ATTACHMENT B-2

PROPOSED CHANGES TO APPENDIX A, TECHNICAL SPECIFICATIONS, OF FACILITY OPERATING LICENSES NPF-72 AND NPF-77, BRAIDWOOD STATION UNITS 1 & 2

Revision	to:	XIX
		XX
		1-4
	3/4	11-1
	3/4	11-3
		6-1
		6-2
		6-2a
		6-5
		6-6
		6-17
		6-20
		6-22
		6-24
		6-27

The proposed amendment makes several changes to the Administrative Controls in Section 6 of Technical Specifications for Byron and Braidwood stations. The proposed changes include (1) a change to the submittal frequency of the Radiological Effluent Release Report, (2) a revision to the Shift Technical Advisor description, (3) clarification of the Shift Engineer's responsibilities, and (4) editorial changes. The references to the Semiannual Radiological Effluent Release Report are also revised in other sections of Technical Specifications.

TABLE 6.2-1

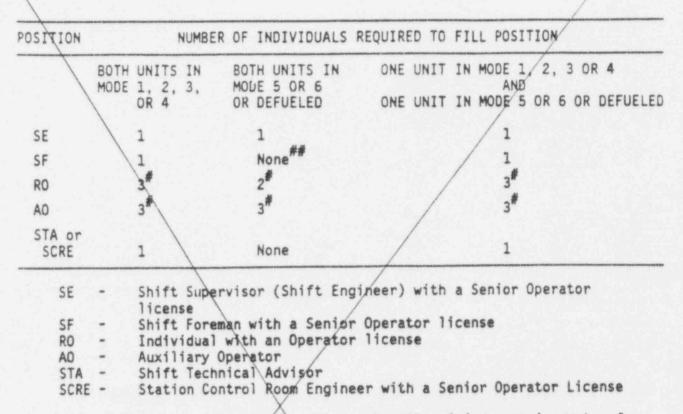
Replace with Insert "A"

INSERT "A"

TABLE 6.2-1

MINIMUM SHIFT CREW COMPOSITION (a) (f)

POSITION (b)	MINIMUM CREW NUMBER		
	EACH UNIT IN MODE 1, 2, 3, OR 4	ONE UNIT IN MODE 1, 2, 3, OF 4, AND ONE UNIT IN MODE 5, 6, OR DEFUELED	EACH UNIT IN MODE 5, 6, OR DEFUELED
SE SRO RO(d) AO(d) STA(C)	1 1 3 3 1	1 1 3 3 1	1 None(e) 2 3 None

- (a) The shift crew composition may be one less than the minimum requirements of Table 6.2-1 for not more than 2 hours to accommodate unexpected absence of on-duty shift crew members, provided immediate action is taken to restore the shift crew composition to within the minimum requirements of Table 6.2-1. This provision does not permit any shift crew position to be unmanned upon shift change due to an oncoming shift crew member being late or absent.
- (b) Table Notation:
